From, Type, Reason	CHAPTER	TITLE	REVISION DESCRIPTION
URR Tariff, Update wording based on updated to the 2025 URR Tariff language.	3.03	Facilities	The costs of the extension will be collected with an Extension Contract or a Revenue Guarantee Recovery Agreement Contract. The Utilities Rules and Regulations, Electric Line Extensions and Services Section 2.A(1), determine when a Recovery Agreement Revenue Guarantee Contract shall be applied to requests for extensions. When, in the sole judgment of Utilities, the costs to administer a Recovery Agreement Revenue Guarantee Contract are prohibitive, an Extension Contract will be administered. Total project costs will be included if a Recovery Agreement Revenue Guarantee Contract is administered.
Christopher Sine, Minimum conduit size for above ground vs below ground CT metering conduit.	5.04a7	Instrument Transformer (CTs & VTs) Metering	CT metering conduits, when required, shall be a minimum 1-1/2" inch for above grade conduit and a minimum 2 inch for below grade conduit size from the transformer pad or CT cabinet to the meter socket, continuous run of either GRC or schedule 40 PVC, with all exposed above ground lengths to be schedule 80

DRAWING 12A - POST TYPE INSTRUMENT TRANSFORMER (CT & VT) METER INSTALLATION (FROM A CT CABINET)

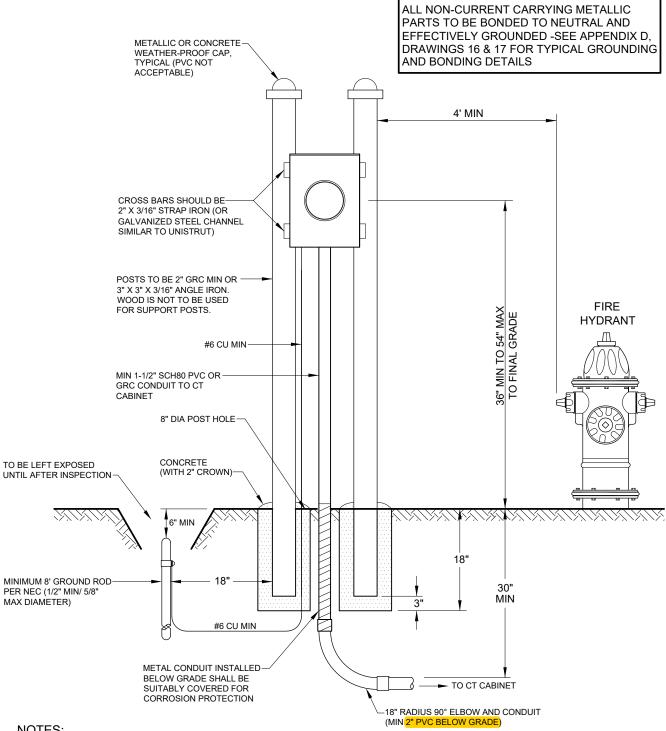
Christopher Sine, -Minimum conduit size for above ground vs below ground CT metering conduitChanged Maximum CT Conduit run length from 35' to 20'.	Appendix D, (Various)	(Various)	-Appendix D, Drawings 12A, 12B, & 13: 18" RADIUS 90° ELBOW AND CONDUIT (MIN 2" PVC BELOW GRADE) -Appendix D, Drawings 14 & 15: 1-1/2" SCH80 PVC OR GRC- 20' MAX,OR EMT- 2' MAX -Appendix D, Drawing 19: 20' MAX and note 7: The CT meter conduit shall be no longer than 20 feet (total length of conduit including all bends)
Christopher Sine, Line/ Load Side feed on Overhead vs Underground Services	Appendix D, Photo 1	PHOTO 1 – THREE PHASE CT CABINET	For Overhead Services, Line Side must be on Top. For Underground Services, Line Side may be on the Bottom or Top.
Elizabeth Ritchey, Clarify color options for AC Disconnect Switch	Appendix D, Photo 6	PHOTO 6 – PHOTOVOLTAIC SERVICE EQUIPMENT LABELING	Customer Provided "AC Disconnect" Placard on AC Disconnect Switch. Color may be black text on yellow background or white text on red background.

- NOTES:
- 1. Meter to be mounted with a maximum distance (total length of conduit run including all bends) of 20' from instrument transformers (CTs & VTs), refer to paragraph 5.04e for instrument transformer conduit installation.
- 2. Both posts must be effectively grounded.
- 3. Refer to trench information, 10.1f (commercial).
- 4. Connect #6 copper conductor from ground rod to ground terminal inside meter enclosure; this ground is in addition to that which may be required by the Regional Building Department.
- 5. Provide pull line for instrument transformer (CT & VT) wire.
- 6. For 277/480 volt services, a VT ("VT Pack") is required.

PAVEMENT REPLACEMENT AND BACKFILL DETAIL

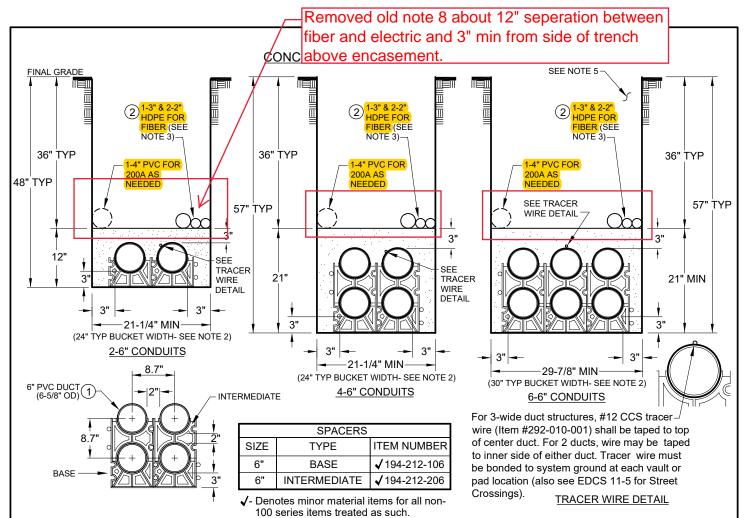
Deleted notes 1 & 2 and moved note 6 to note 1 position.

- 1. All work to be in conformance with City of Colorado Springs Public Works specifications (https://coloradosprings.gov/public-works/page/standard-specifications-manual). Refer to other authority if using state highway or county roads.
- 2. When suitable, use native material compacted as specified on page 2. If native soils are not suitable, install flowable fill, Colorado Springs T&D Mix #3 as specified on page 5.
- 3. Flowable fill is required for street crossing trenches one foot or less in width.
- 4. Utilize the boring crew/contractor when appropriate for recently repaved streets, etc.

CONCRETE ENCASED DUCT BANKS

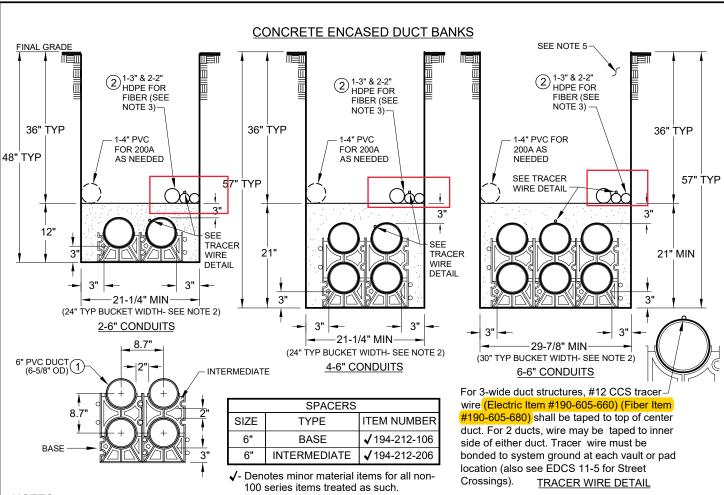
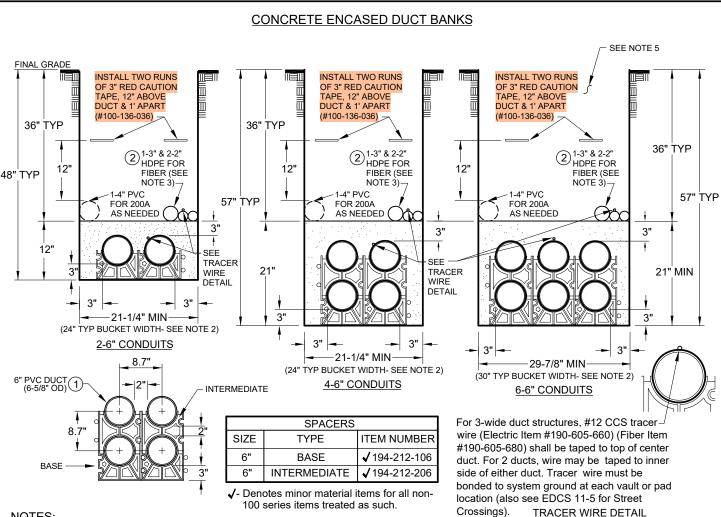
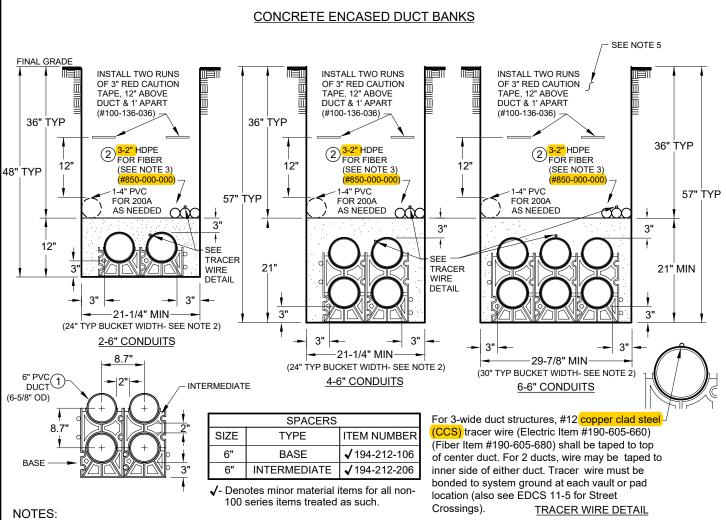
Updated notes and drawings for Fiber conduit and tracer wire. Added note about trench marking tape.	Appendix F, 11-2	Concrete Encased Duct Banks	-Updated notes and drawings for Fiber conduit and tracer wireAdded trench marking tape note to drawing: "INSTALL TWO RUNS OF 3" RED CAUTION TAPE, 12" ABOVE DUCT & 1' APART (#100-136-036)"
